Amendments to the Drawings

The attached sheets of drawings includes changes to Figs. 2-4, 7, 10, 12-14. These drawing sheets replace the original sheets including Fig. 2-4, 7, 10, 12-14.

USSN 09/924,294
Replacement Sheet

FIG. 2

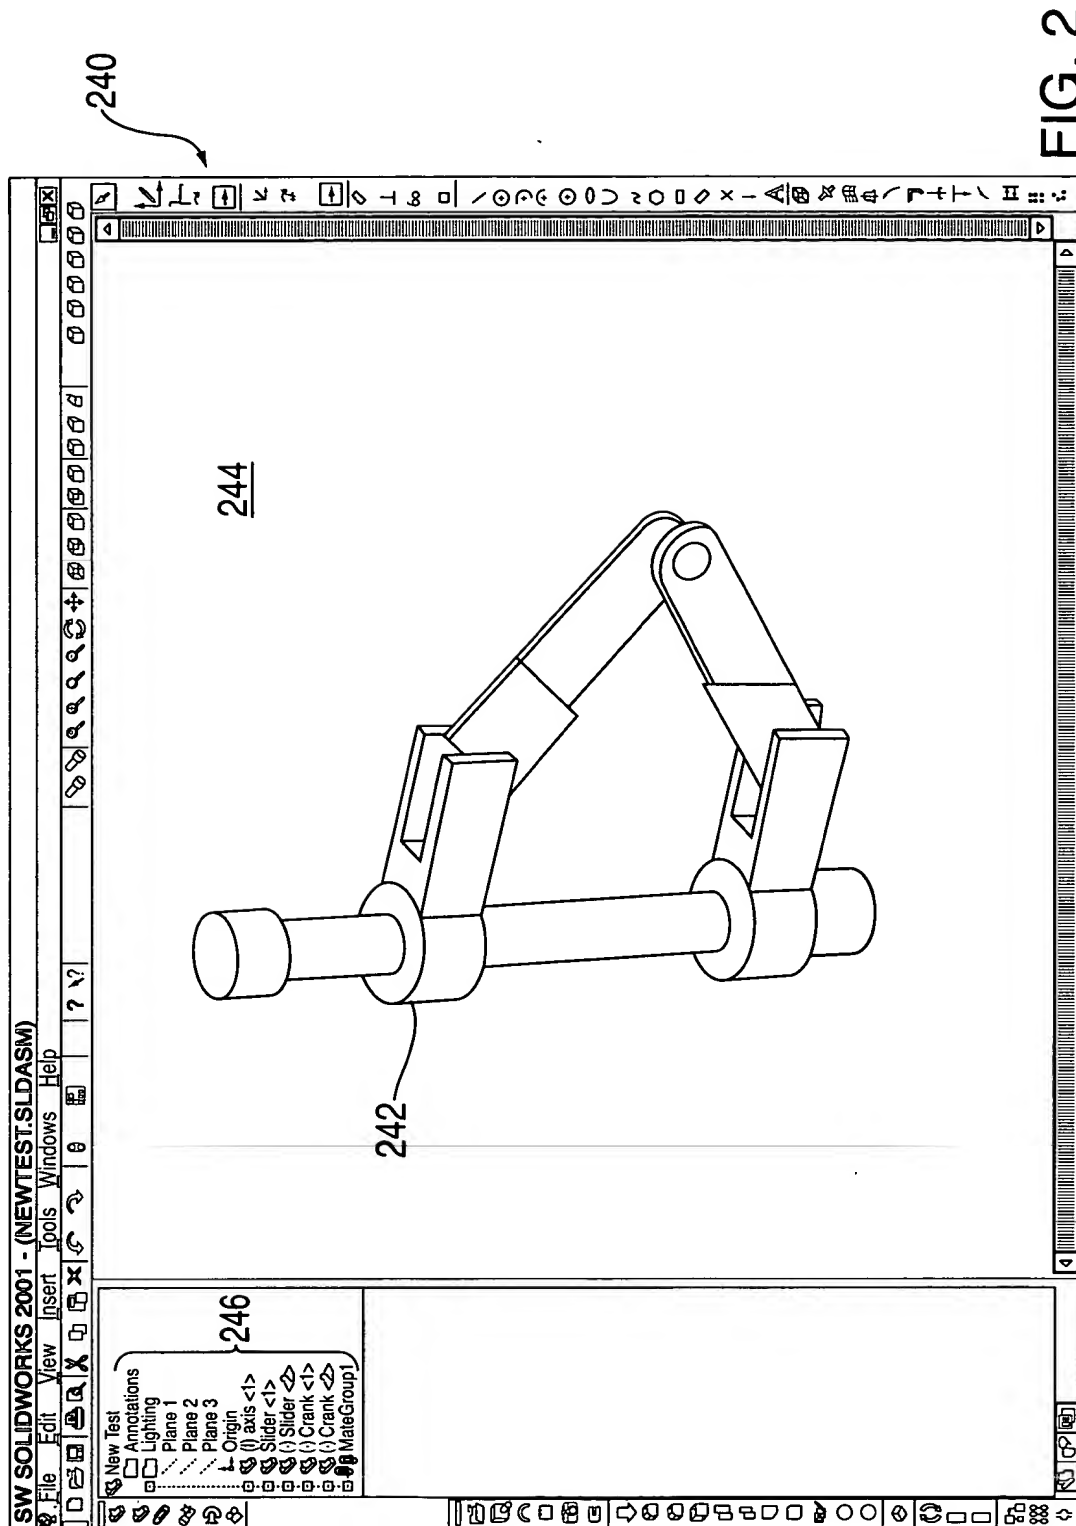
In Fig. 2, the display window has been labeled "240."

FIG. 3

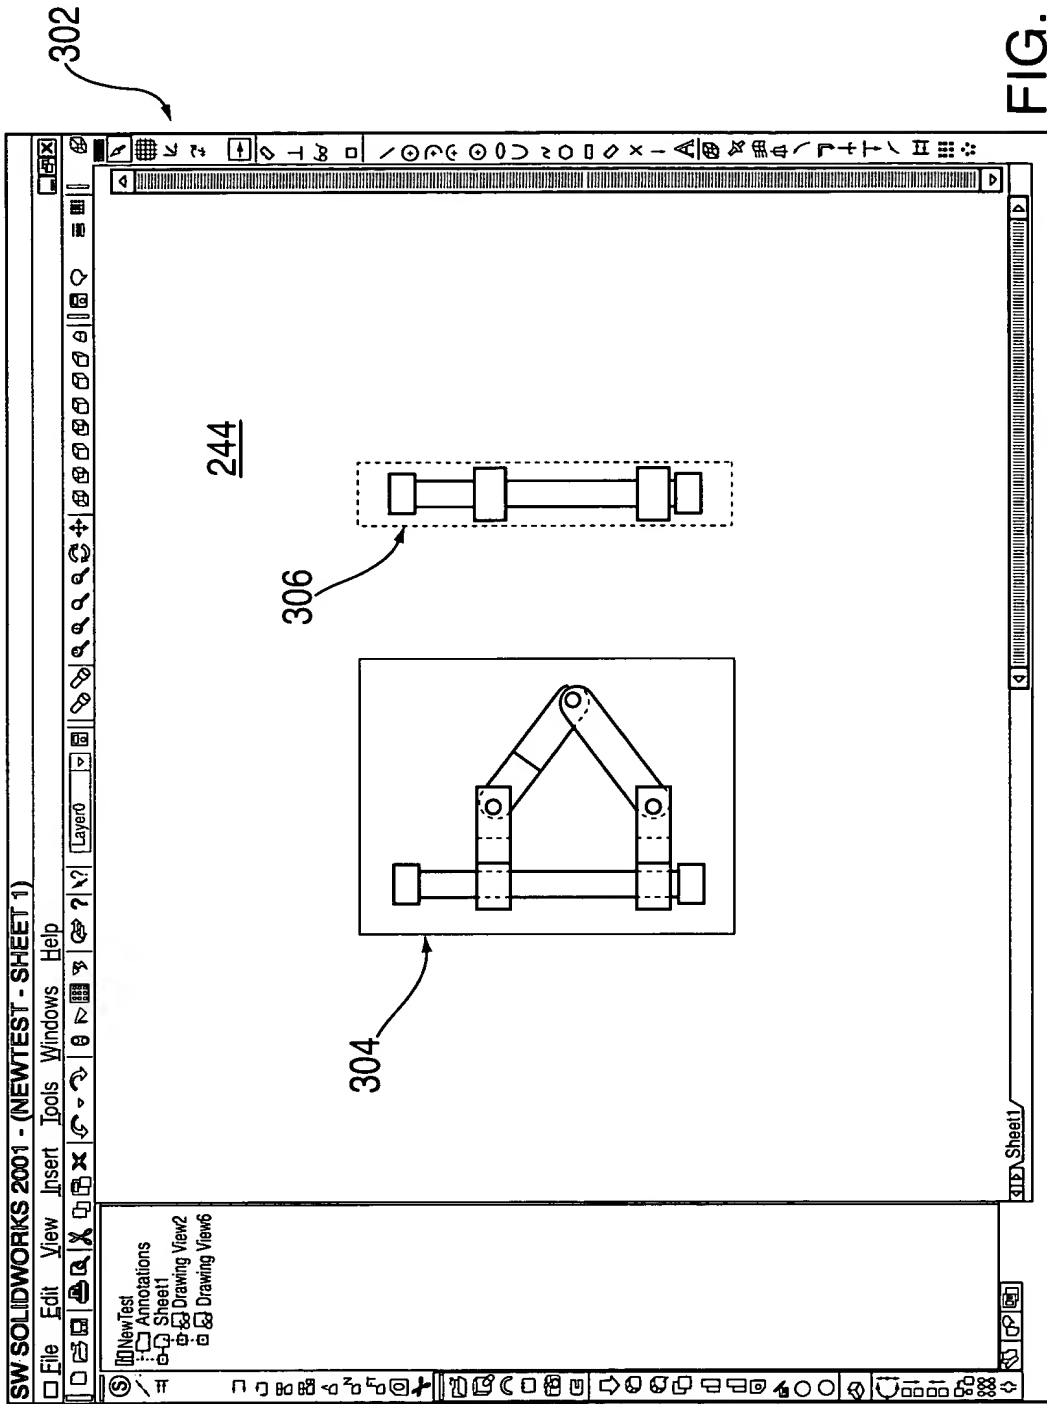
In Fig. 3, the display window has been labeled "302."

FIG. 4

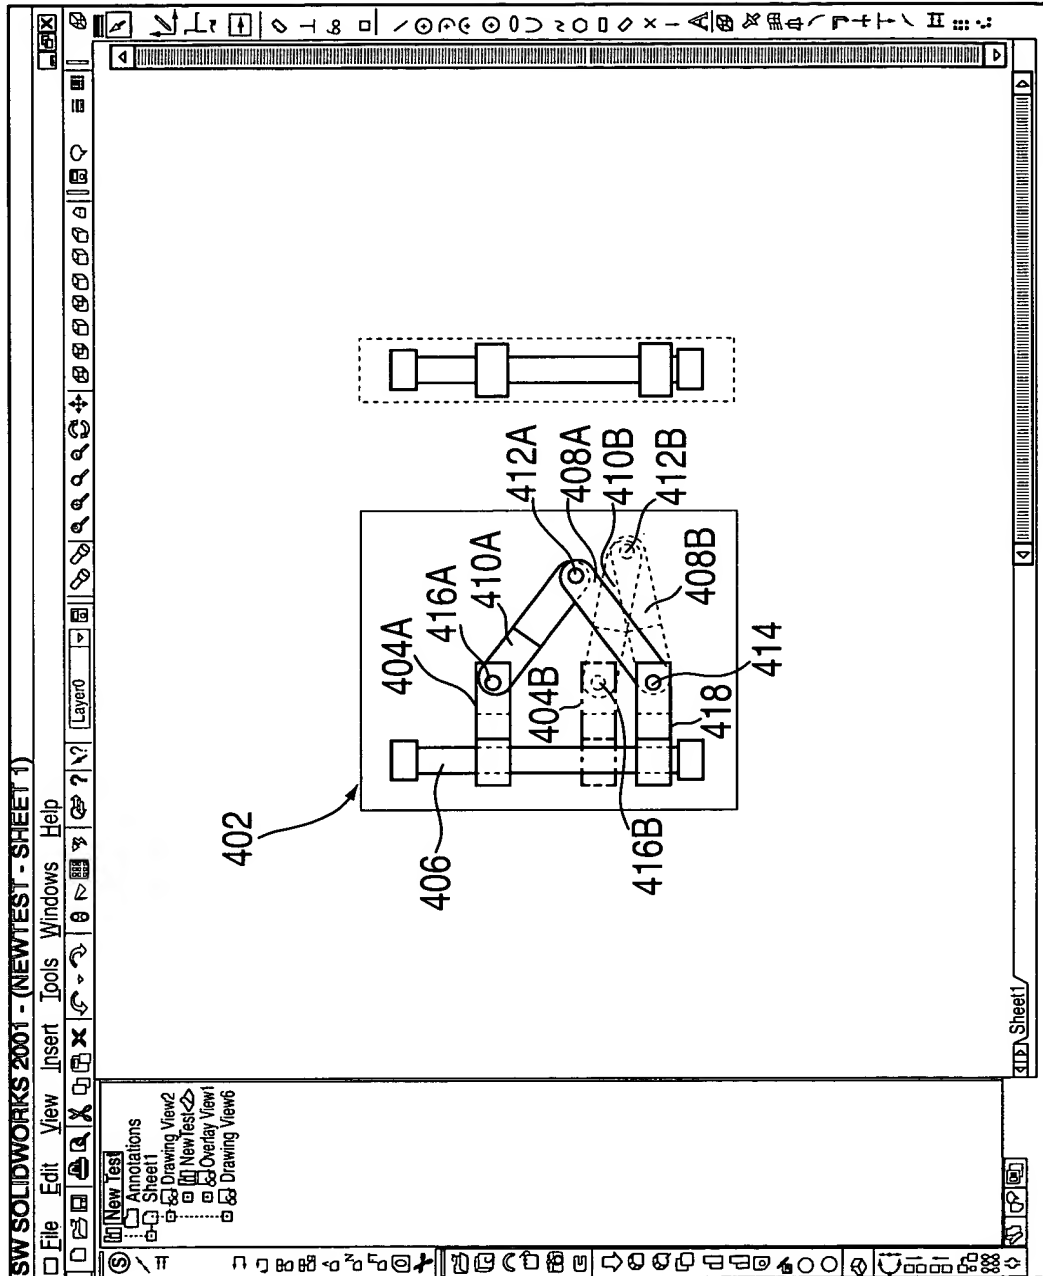
In Fig. 4, the display window has been labeled "400."

FIG. 7

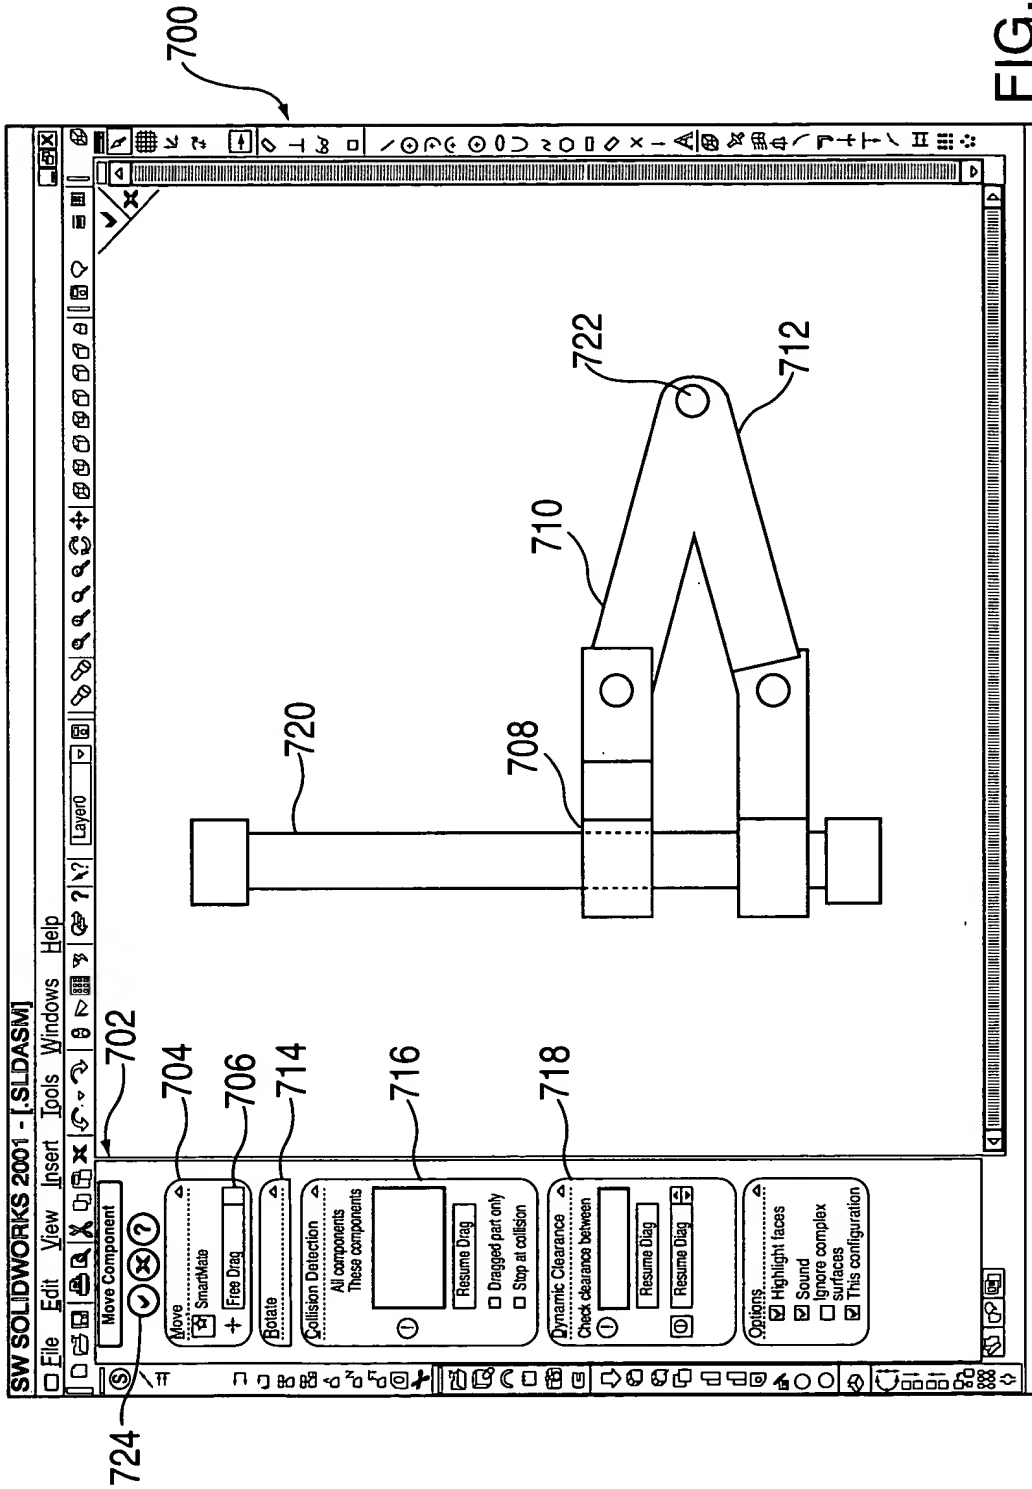
In Fig. 7, the display window has been labeled "700," the shaft has been labeled "720" the pin has been labeled "722" and the checkmark button label has been changed to read "724."

FIG. 10

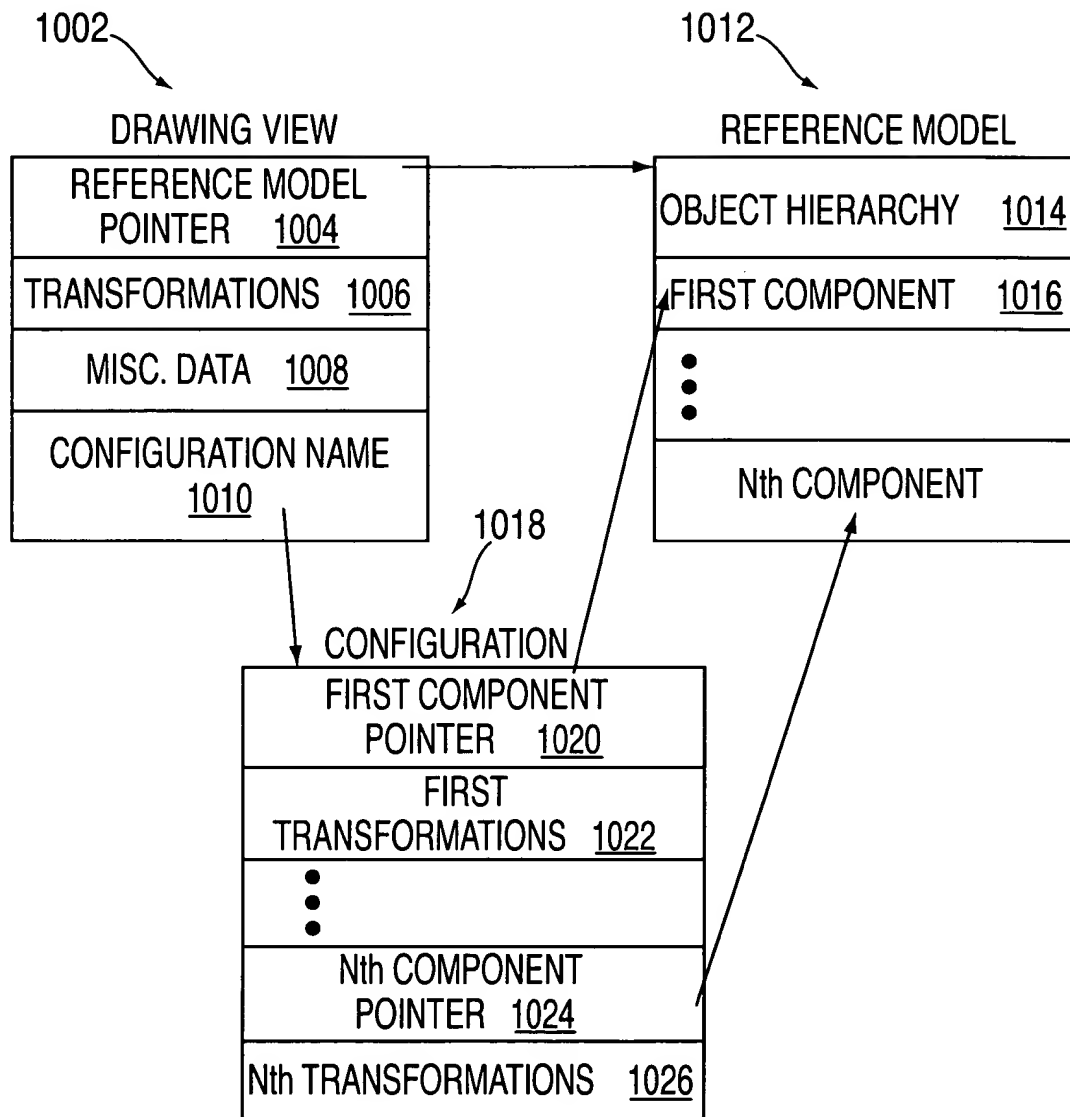
In Fig. 10, an incorrectly drawn arrow connecting boxes 1002 to 1012 has been fixed.

FIG. 12

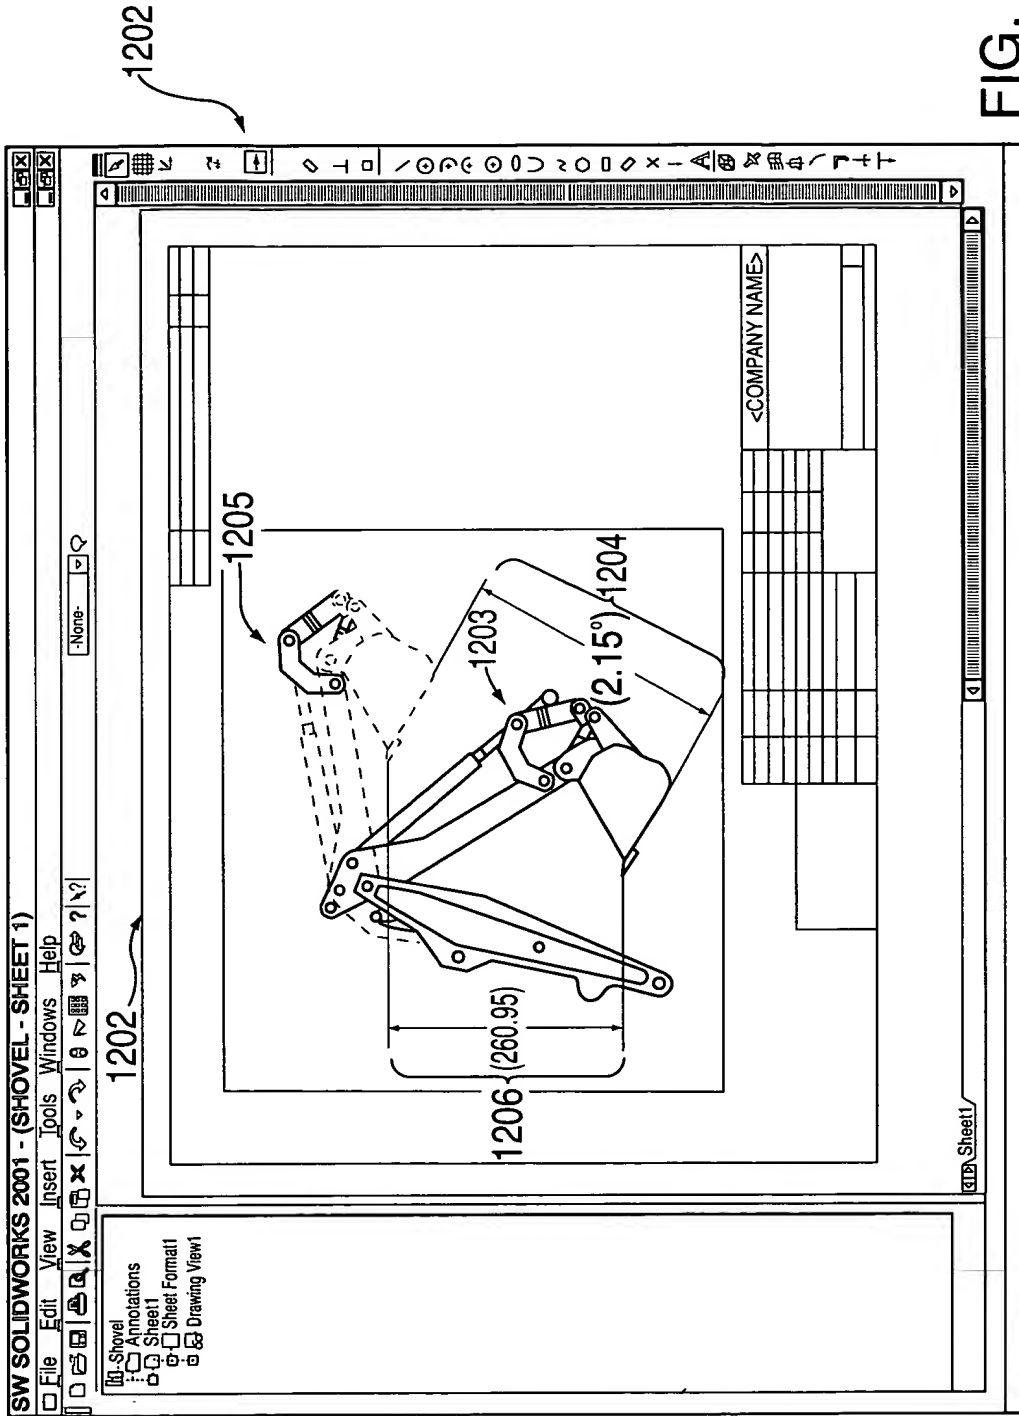
In Fig. 12, the display window has been labeled 1202, the change has been made to an arrows connected to reference labels 1203 and 1205.

FIG. 13

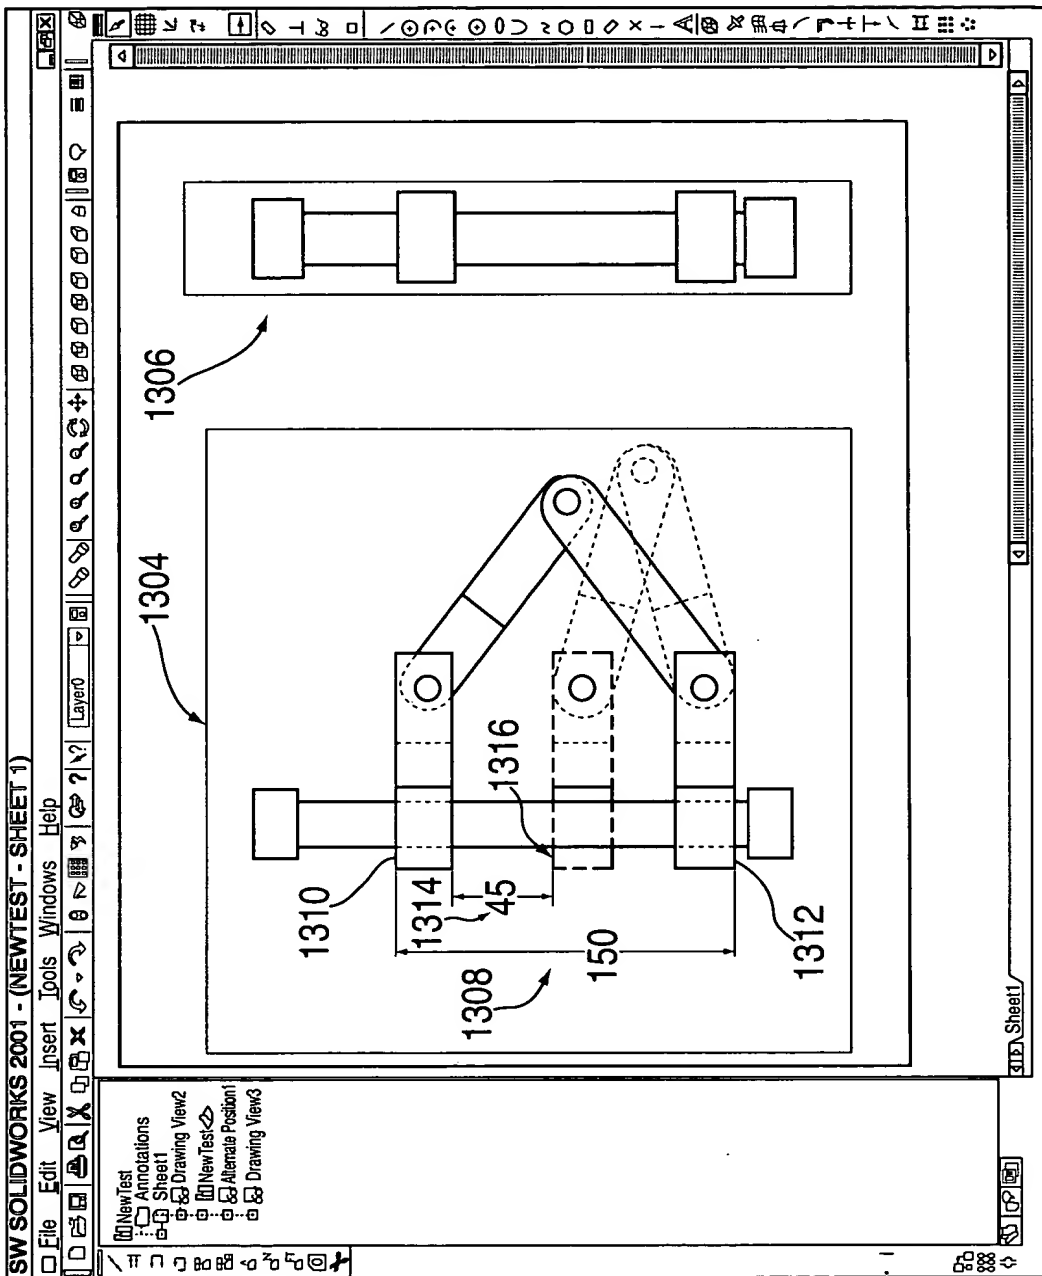
In Fig. 13, the element reference 1302 has been changed to more clearly identify the referenced element.

FIG. 14

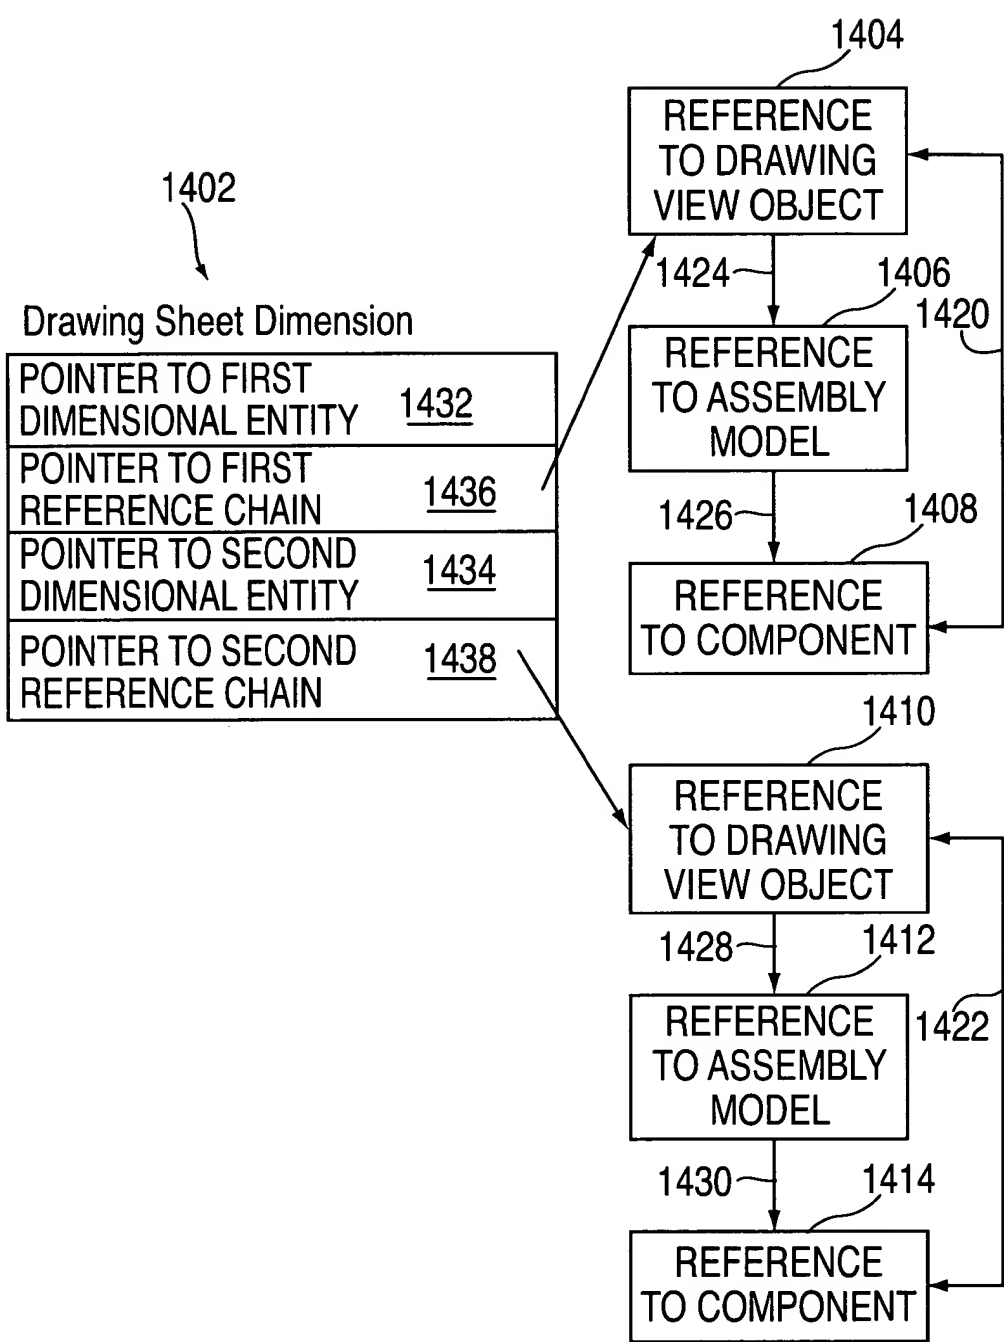
In Fig. 14, a connecting arrow has been corrected.
